Access Compliance Report

Public Rights-of-Way

(Curb Ramps)

Intersection ID: 50532	Main Street: STRAUSE_DR	Cross Street: SAMLEN_LN	Location: NE
ADA ID: 73EA2EC5C72C	Ramp Type: PerpDiag	Initial Pass/Fail: Fail	Overall Compliance: No
		Severity Score: 8.75

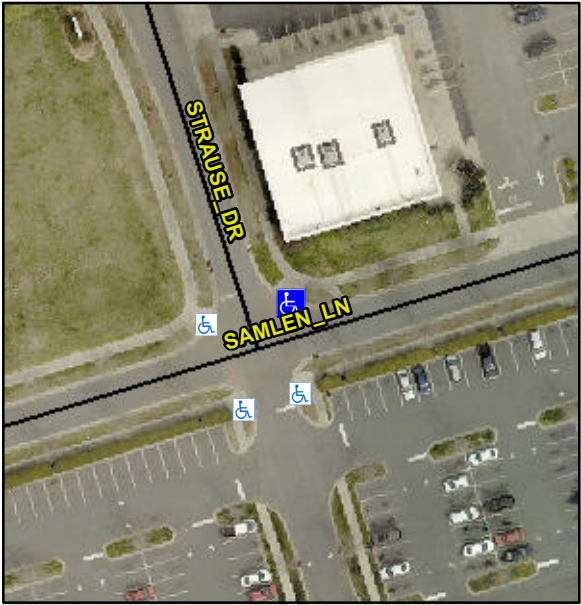
Codes/Mitigation Info/Possible Solution			Field Measurements/Component Compliance		
	Possible Solutions:		Compliance	Description	Data
	Remove & Replace Curb Ramp With Two New Directional Ramps or Equivalent.		Yes	Ramp Length (in)	96.0
			No	Ramp Width (in)	45.0
			N/A	Flare Type LT	N/A
			N/A	Flare Slope LT (%)	N/A
			N/A	Flare Traversable LT?	N/A
			N/A	Landing Length (in)	N/A
			N/A	Landing Width (in)	N/A
			N/A	Landing Slope (%)	N/A
			N/A	Landing X Slope (%)	N/A
<p>Surveyor Notes:</p> <p>N/A</p> <p>PROW/ADA:</p> <p>Not Found, R304.5.1</p>			N/A	Flare Type RT	N/A
			N/A	Flare Slope RT (%)	N/A
			N/A	Flare Traversable RT?	N/A
			N/A	DWS Provided?	N/A
			N/A	DWS Contrast?	N/A
			N/A	DWS Length (in)	N/A
			N/A	DWS Full Width?	N/A
			N/A	DWS Offset (in)	N/A
			N/A	Shared Landing?	N/A
			N/A	Gutter Ponding?	N/A
			N/A	Gutter Lip Ht (in)	N/A
			N/A	Painted X Walk1?	Yes
				X Walk 1 Direction	To W
			N/A	X Walk 1 Width (in)	122.0

X Walk 1 Slope (%)	2.1
				X Walk 1 X Slope (%)	1.6
			N/A	Ramp inside XWalk1?	Yes
			N/A	Road Slope (%)	0.8
			N/A	Road X Slope (%)	1.0
			N/A	Any Obstructions?	N/A
				Obstruction Type	
			N/A		
			N/A		
			N/A		
			N/A		
			N/A		
			N/A		
			N/A		
			N/A		
			N/A		
Total Cost:		\$ 3200.00			
Street 1 Name	STRAUSE DR				
Stop Condition-Street 2	StopSign				
Street 2 Name	SAMLEN LN				
Stop Condition-Street 1	None				
			Yes	Surface Condition? (G/P)	Good
